**SUBJECT: DRAFT SEIR for the BART Warm Springs Extension (WSX)**

## Response to Comment Letter 12 (City of Milpitas)

Figure 3.10-6a  
Project-Induced Noise Impacts

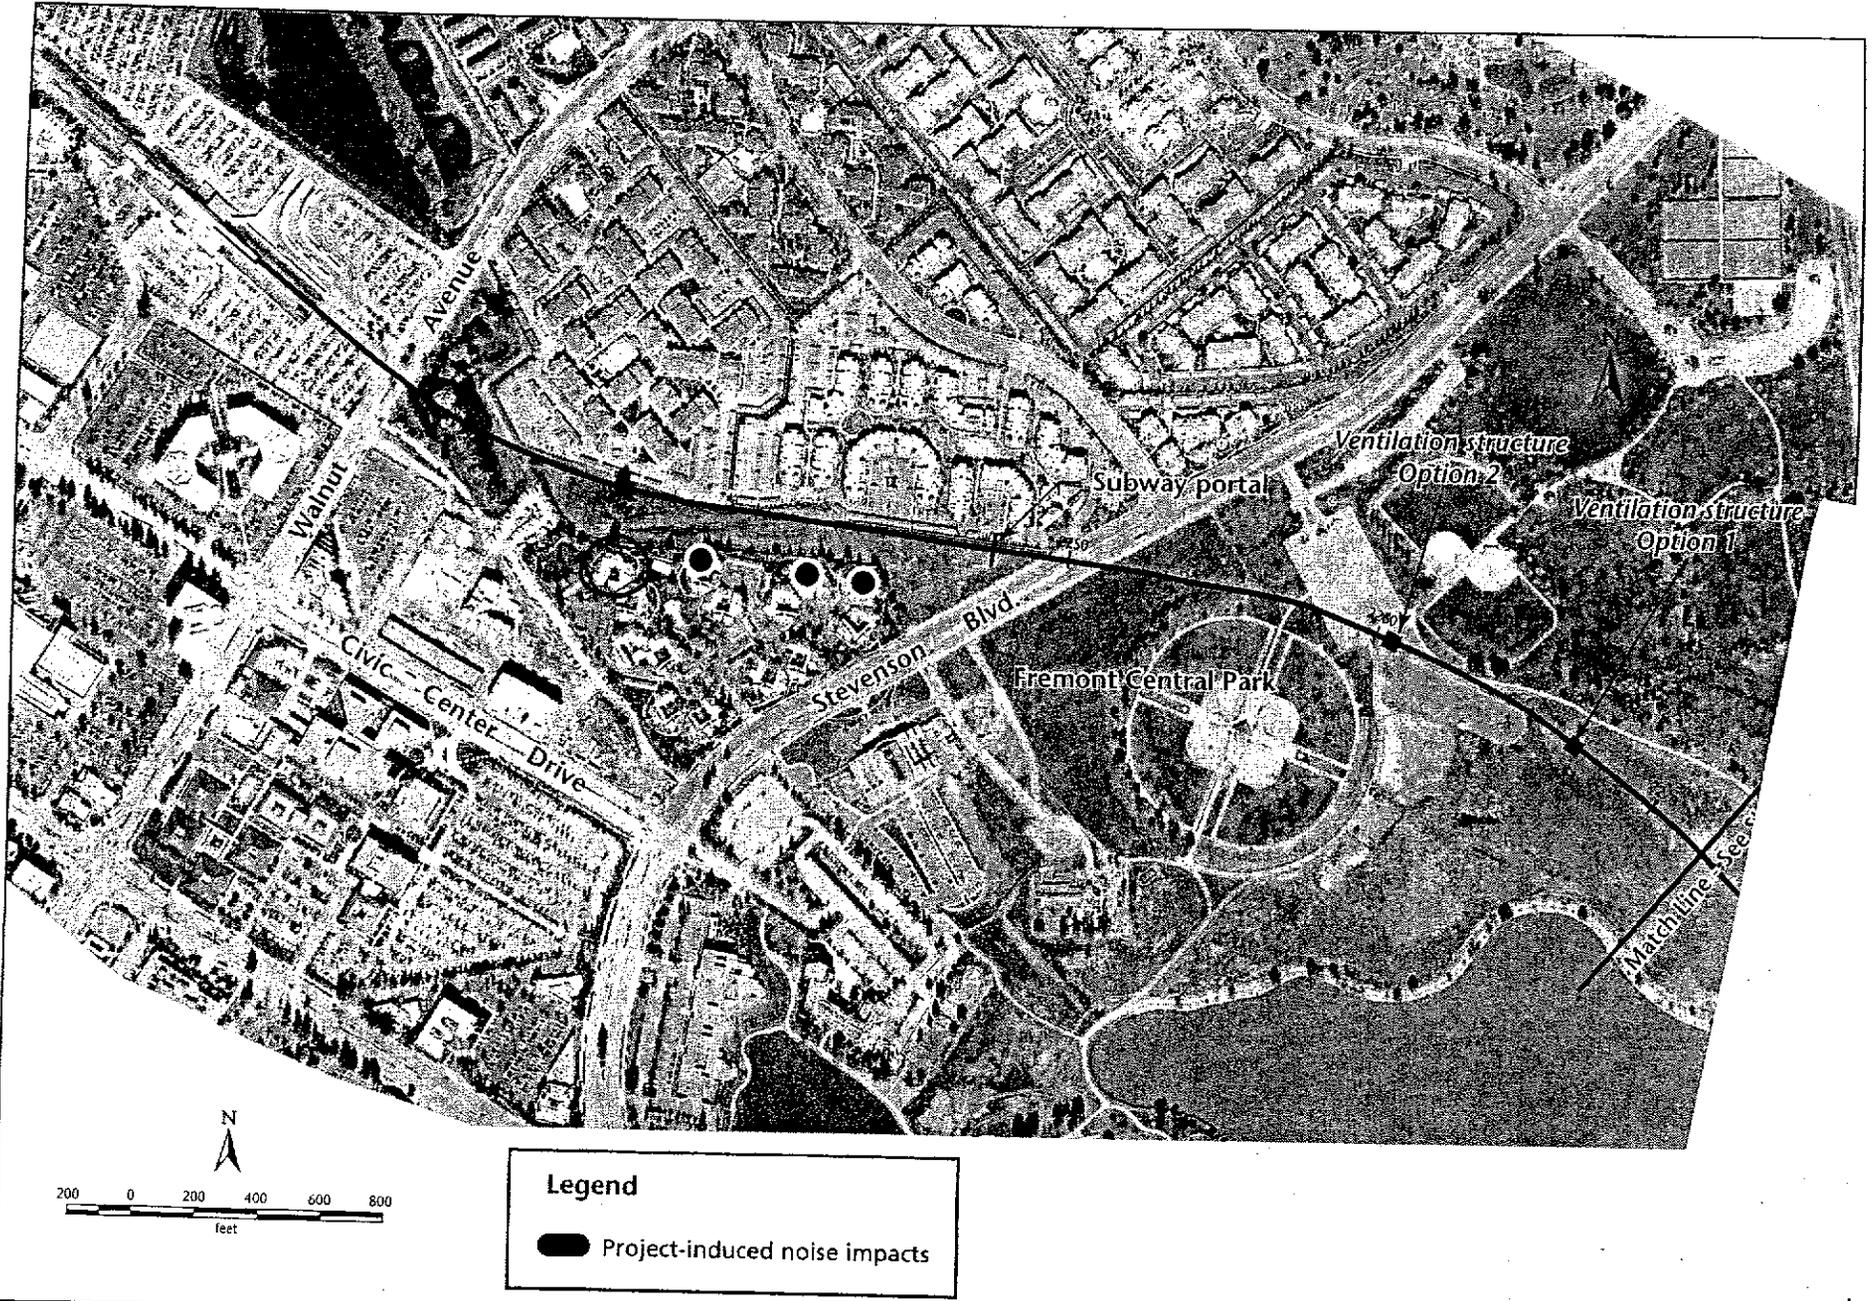
7) No current assessment was made of the existing noise conditions at Fremont Villas. Pages 3.10-6 through 3.10.8 show this. It was assessed during the 1992 report. We are one of the closest residential areas for the entire project and I am in one of the closest buildings and no current assessment was made. I don't want to sound dramatic here, but I feel like we're being left out. The report states on page 3.10-6 that "estimating existing noise exposure is an important step in the noise impact assessment because the thresholds used to assess the significance of cumulative noise impact are based on existing levels of noise exposure." Shouldn't existing noise levels be evaluated here? I think it is quieter here than the closest location evaluated, Red Hawk Ranch Apartments. If that is proven it to be true, it would mean we may have a greater cumulative noise impact.

21-7

- 21-2** Figure 3.7-4 on page 3.7-14 of the DSEIR has been revised to show a simulation of how a noise barrier would look if placed on the BART embankment. The revised figure follows this page. Table 3.10-9 on page 3.10-32 of the DSEIR identifies the portion of the Proposed Project alignment adjacent to Fremont Villas as a potential location for noise barriers.
